Permit Renewal Application **HAND DELIVERED**
for the
Garfield County
John's Valley Class II Landfill

REQUEST FOR ADDITIONAL INFORMATION #1

May 3, 2004

Cover - Unlined Cell

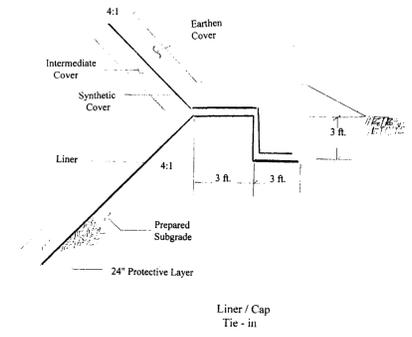
Exhibit 8 drawings contain cross section of the lined and unlined cell. The drawings show manufacturer required cover of unspecified thickness, manufacturer required buffer layer of unspecified thickness, manufacturer required base of unspecified thickness. What are these material, purposes, and thickness?

The cost estimates must be related to the specific design provided in the application. For example, the unlined cell cover cross section in Exhibit 8 shows the manufacturer required base. The specific design details of the manufacturer base material in thickness and volume must be identified to provide a detailed cost estimate.

See plans

Cover - Lined Cell

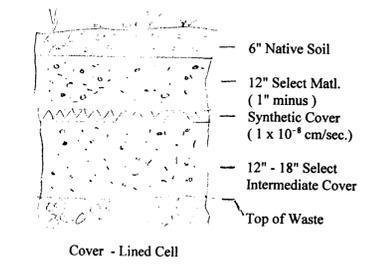
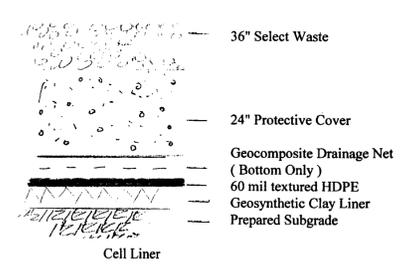
The Exhibit 8 drawing of the lined landfill final cover does not show a drainage layer.

- Details of how the water will move off the final cap liner will need to be included in the application. *Slopes w/ arrows -*
- A detailed cross sectional drawing needs to be provided to show how the final cover liner design ties into the bottom liner. *Detail*

Cell Liner

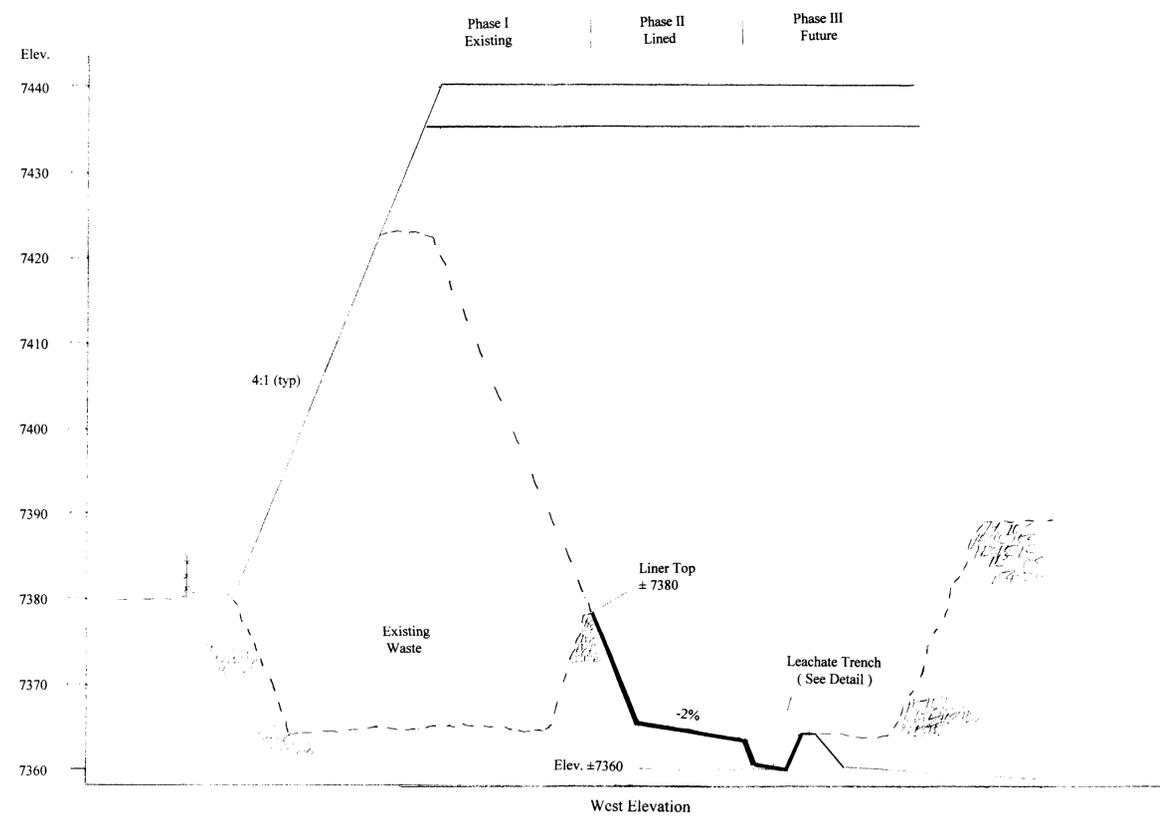
The Exhibit 8 cross-sectional drawing of the bottom liner system does not include drainage net, leachate collection layer, or leachate collection pipes.

- The application needs to provide the details of the leachate collection system and make necessary changes to the drawings. *detail*

Leachate Trench Detail

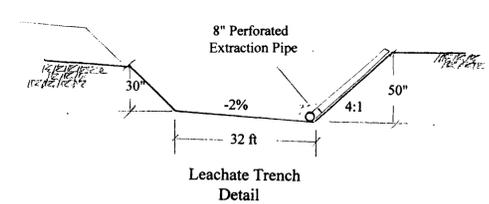
- The application needs to include the modified design of the leachate collection trench.

See Plan
